**CWM CHEMICAL SERVICES, LLC**

Re: SPDES Permit #NY0072061 Modification Request for RMU-2

## STORM WATER FLOW SCHEMATIC & MONITORING LOCATIONS

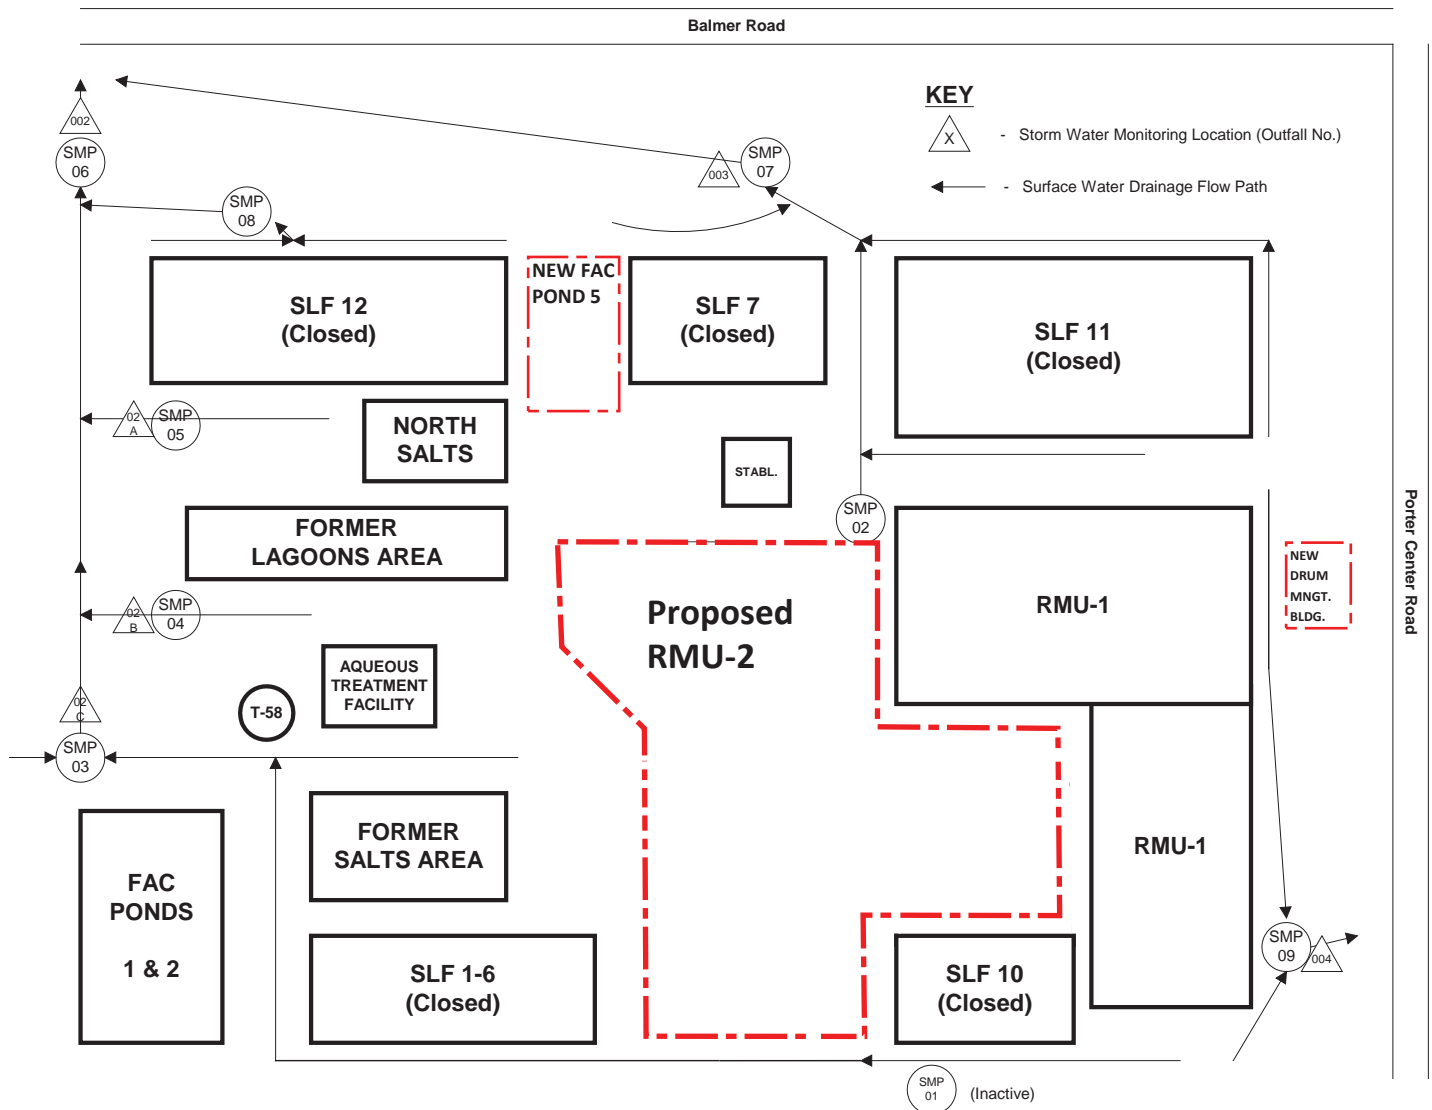
minor modification to the facility's SPDES Permit #NY0072061 will be required. The requested minor modification consists of a revised Storm Water Flow Schematic and Monitoring Locations diagram found on Page 29 of 32 of the renewed SPDES Permit. The changes to this diagram include the removal of Fac Ponds 3 and 8 upon closure, the addition of new Facultative Pond 5, the addition of RMU-2, and revised surface water flow patterns. We do not believe that there is the need to make any other modifications to the just renewed SPDES Permit in light of the development of RMU-2.

Revised: April 23, 2015
